**PROTERRA**

# IMPROVEMENT OFFERING

<b>ISSUE DATE:</b>	9/7/2021
<b>SERVICE BULLETIN SUBJECT:</b>	Underbody Horn Shield Retrofit
<b>VINs or MODELS AFFECTED:</b>	Service Specified Buses
<b>COMPLETE BY:</b>	Next Service Opportunity
<b>SERVICE BULLETIN #:</b>	SC-21-121
<b>LABOR OPERATION CODE:</b>	UU46H

## UNDERBODY HORN SHIELD RETROFIT

Remove Bottom  
Two Locknuts

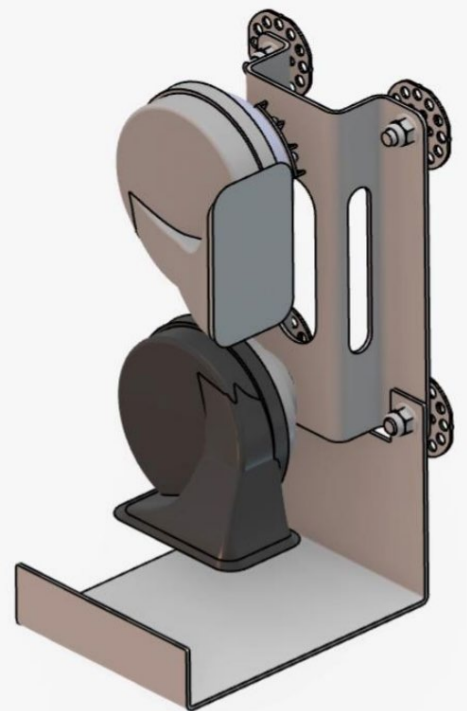
1. Complete the Proterra approved Lockout/Tagout procedure to make the bus safe for work.
2. Using a 10mm Ratchet/Socket, remove the two locknuts that secure the bottom of the Horn Assembly to the bus body. Discard the Locknuts. They will not be reused.

3. Place the Cover (027937 ) on top of the Horn Bracket as shown in the following illustration.

4. Using a 10mm Ratchet/Socket, secure the Cover (027937) to the Horn Bracket with two new Locknuts (018575) from the kit.
5. Using a Calibrated Torque Wrench with a 10mm Socket, **torque the Locknuts (018575) to 71 inch pounds.**
6. Using Orange Torque Stripe Paint, mark the properly torqued fasteners.
7. Remove the Lockout/Tagout devices and return the bus to service.
